SUN 'N LAKE

EMS / FIRE STATION

ADDENDUM - 3-7-2017

REVISED PLANS - ADDENDUM NO. 1 MARCH 27TH, 2017

DRAWING:
 FRONT & REAR ELEVATIONS

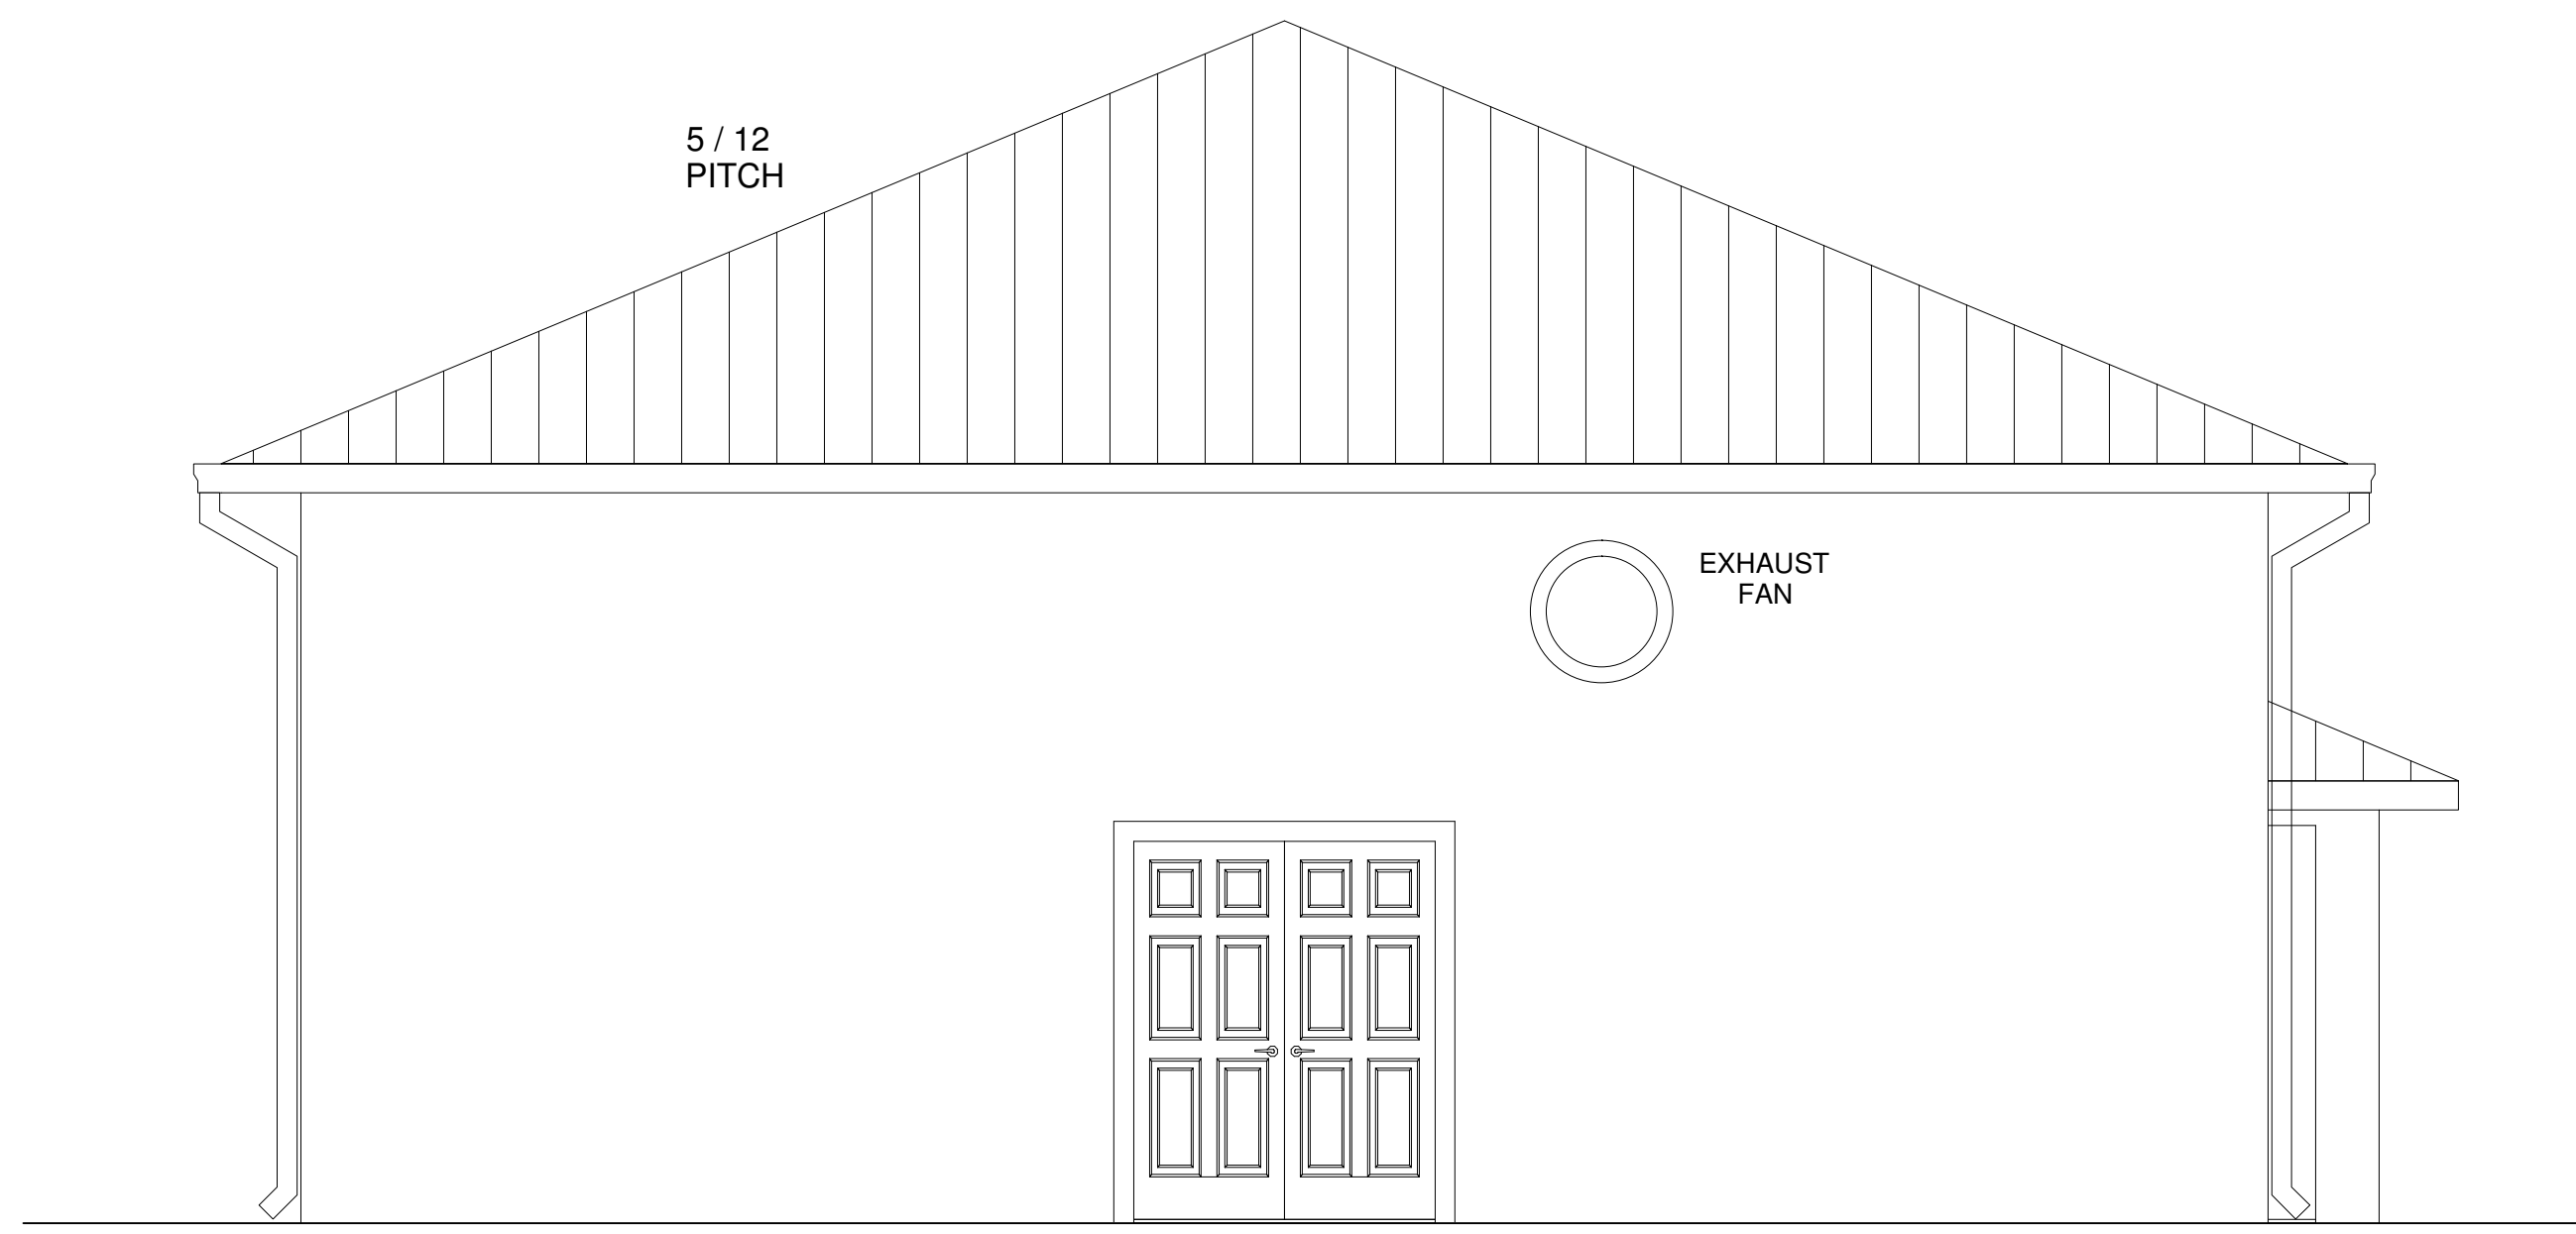
DOWNSPOUTS ADDED AS SHOWN AT FRONT OF BUILDING WITH A CONCRETE SPLASH PAD TO DISSIPATE THE DISCHARGE.

ADDENDUM - 3-7-2017

DOWNSPOUTS ADDED AS SHOWN AT REAR OF BUILDING WITH A CONCRETE SPLASH PAD TO DISSIPATE THE DISCHARGE.

CERTIFICATE OF AUTHORIZATION #5884
 ROGER DALE POLSTON P.E. # 33222
 MARVIN LUTHER VOLPE P.E. # 46838
 REGISTERED PROFESSIONAL ENGINEERS
 STATE OF FLORIDA
 SCALE: 1/4" = 1'-0"
 GUTTERS ADDED (SEE ELEVATIONS)
